# 121 12th Avenue E

Recommendation Meeting - May 6, 2015  
DPD Project #3017532  
Updated Recommendation Packet

b9 architects

1 12th Avenue E

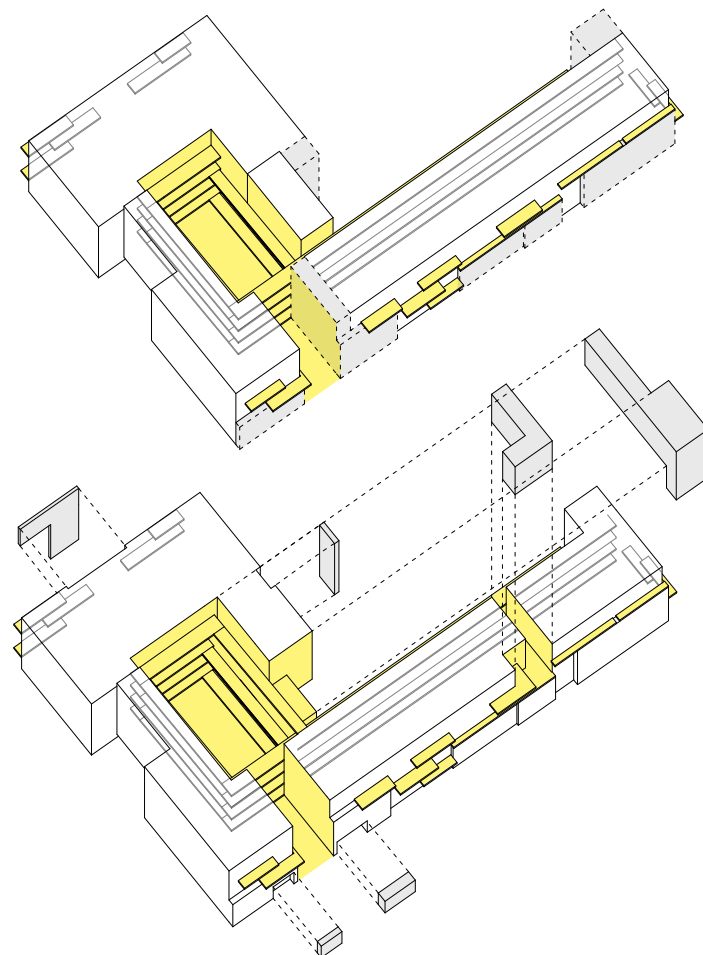
The Board was particularly concerned with the lack of variation in the three design options. After considerable discussion, four of the six Design Review Board members gave guidance to develop massing alternative three and proceed to MUP application. The Board felt the preferred massing alternative three provided a better design response to context by locating courtyard as a centerpiece of the design. The Board noted that significant efforts will be necessary to resolve street façade articulation and massing.

- a) The Board directed the applicant to use modulation and articulation at the 12th Avenue E façade to reduce the perceived façade length and create a more pleasing proportion to the overall building (CS2-C2).
- b) The Board reviewed cumulative setback provided along the south property line, which measured between 14-16 feet, and recommended that it was sufficient (CS2-D5).
- c) The Board noted the facades facing adjacent residential structures should be designed to minimize disrupting the privacy of residents in adjacent buildings (CS2-D5).

- Massing and material modulation have been designed throughout the project to reduce the perceived facade length along 12th Avenue E as well as to provide visual interest and rhythm at each exterior facade.
- Deck projections at the exterior facades continue the architectural language of the exterior decks connecting the units and the shared courtyard and provide further rhythm along the exterior facades.
- Generous setbacks are provided at the side and rear property lines and an architectural screen is proposed for half of the exterior walkway along the west side setback. This provides screening for privacy to the adjacent structure as well as works to shorten the perceived length of the exterior walkways.

2 Corner View at 12th Avenue E and E John Street

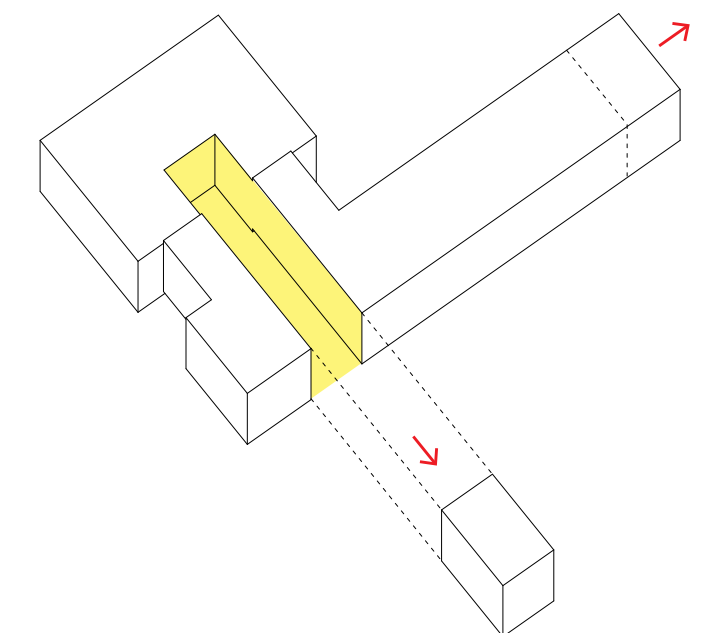
The Board directed that the prominent location on the corner of two major streets necessitated an architectural response at the corner.

- a) The Board felt that the treatment and articulation of the corner should inform the overall façade articulation and proportion on 12th Avenue E (CS2-C1).
- b) The Board was particularly concerned about the location of the electrical vault and solid waste storage space along the narrow E John Street facade. The Board directed the applicant to work with Seattle Public Utilities and Seattle City Light to identify an appropriate location for services. The location should be chosen to be sensitive to adjacent sites (DC1-C2 and C4).
- c) Once a location is determined for solid waste, the street level façade must be designed along the sidewalk to minimize visual and odor impacts (DC1-C2 and C4).

- The proposal provides a strong architectural move at the corner of the site with projecting volumes and decks and high quality materials including dark brick, vertical cerclad siding and steel railings. The massing and glazing strategies at the corner continue throughout the rest of the project to create a unified design.

- Coordination with Seattle Public Utilities confirmed that the location of the trash/recycling storage area in the west setback with access to E John Street is ideal. The trash/recycling storage area will be enclosed to reduce visual and odor impacts and will be sided with a screening material to compliment the architectural screen proposed along the west facade.

- The project team is coordinating with Seattle City Light to re-locate the transformer vault away from the corner to the below-grade story. This allows the corner to have a clearer and more consistent massing and glazing strategy.

3 Courtyard Entry View

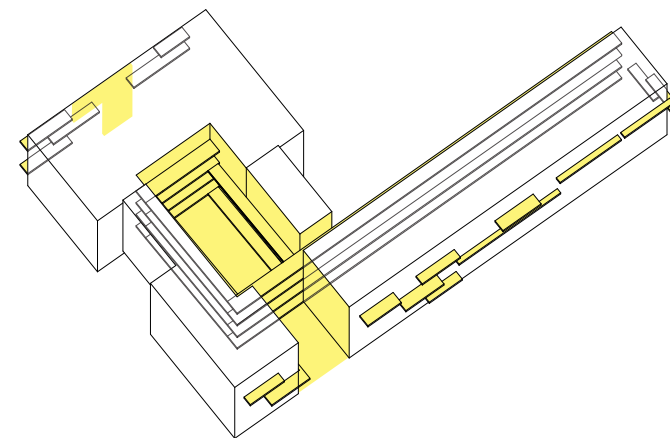
The Board stated that the provided courtyard was consistent with the Capitol Hill vernacular. The Board noted that Design Alternative three provided the best design response to the context by minimizing impacts to adjacent residential structures.

- a) The Board directed that the courtyard space be expressed visibly along the street façade. At the Recommendation Meeting the applicant should demonstrate how the courtyard is read from the adjacent 12th Avenue right-of-way (DC3-iii, CS2-B2).
- b) The bicycle entry and storage space should be resolved within the overall flow of the building (PL4-B2).
- c) The Board expressed concern about the viability and privacy of below grade units facing the street and the common entrance walkway. The Board directed the applicant to design these spaces with a comfortable transition between the unit and public area, incorporating design techniques used in Crime Prevention through Environmental Design (PL3-B).
- d) The landscape plan should maximize tree canopy with the courtyard and setback spaces (DC3-iii).

- The project design concept emerges out of the geometry of the site, created through a linear element that wraps around a central courtyard. A combination of landscaping, pavers, trellis, varied massing and contrast in materials and colors all contribute to the expression of the courtyard along the 12th Avenue E facade. The opening to 12th Avenue E provides entry for the building, with all access through the courtyard. Colors and materials, fenestration, landscaping, furniture terraces above grade and bike parking encourage activity and lingering for visitors and residents. The trellis identifying the courtyard entry with signage and color is similar in form and projection to the decks above.

- 51 bicycle parking spaces are provided in this project with 15 exterior spaces provided at grade in the shared courtyard and 36 interior spaces provided in the basement with stair and elevator access.

- The partially below-grade units at the street are setback from the sidewalk to provide a buffer for safety and privacy. A 3 foot tall planting screen is proposed in front of the units as well as a mixture of taller and shorter plantings arranged to create a layering affect that provides further privacy to the units. The partially below grade units are designed to allow daylight in and view out without impacting privacy.

- The Landscape Design maximizes tree canopy and plantings at multiple levels throughout the project, particularly in the setbacks and in the central courtyard.
